PARTS & SERVICE NEWS

REF NO. AT04179

SUBJECT: REPAIR PROCEDURE OF FUEL HIGH PRESSURE PIPE

The fuel high pressure pipe between the fuel supply pump and the common rail on SAA6D140E-3 engine may be cracked. Make repairs by following procedure provided in this **Parts & Service News**.

Fig. 1

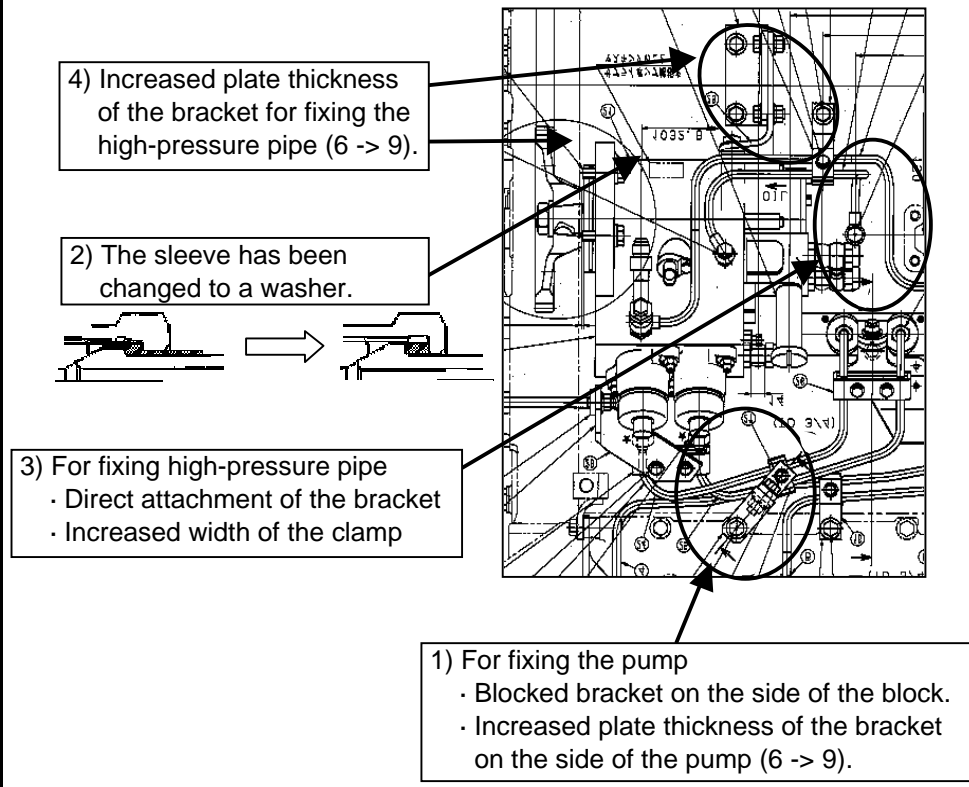
1. Detail of modifications

Fig. 2

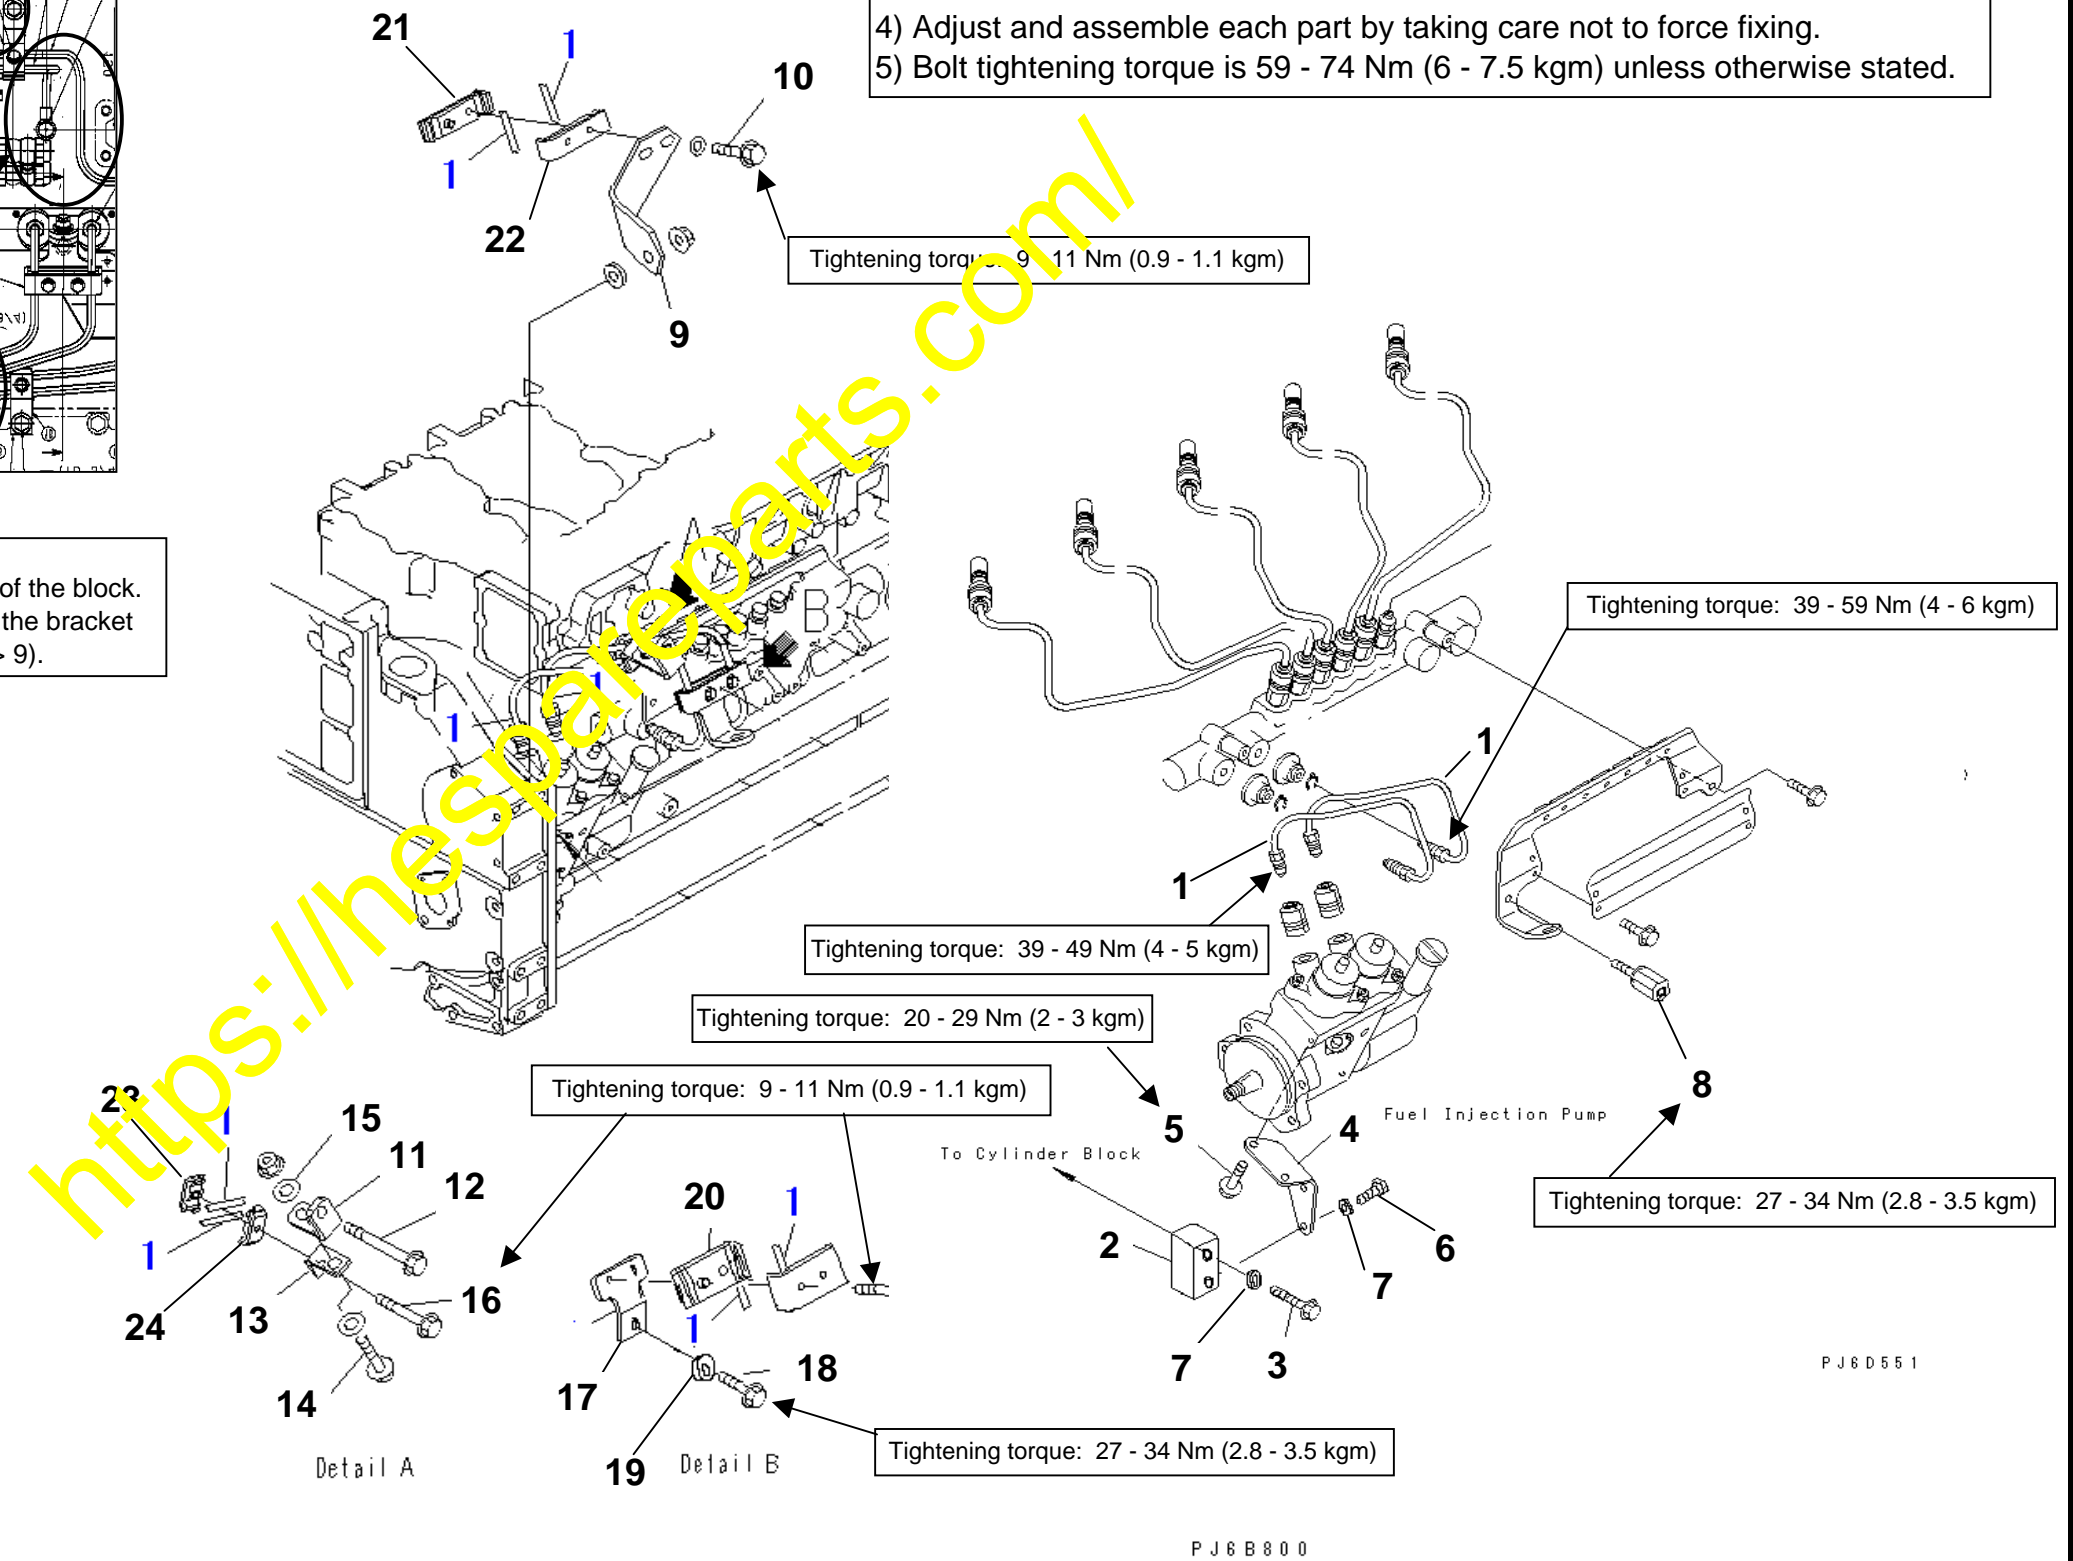
- 1) Replace with the modified parts in accordance with Fig. 2.
- 2) The numbers in the diagram match the diagram numbers in the remark column of the list of modified parts.
- 3) Though no modification was made to the clamps 21 thru 24, replace them with new ones.
- 4) Adjust and assemble each part by taking care not to force fixing.
- 5) Bolt tightening torque is 59 - 74 Nm (6 - 7.5 kgm) unless otherwise stated.
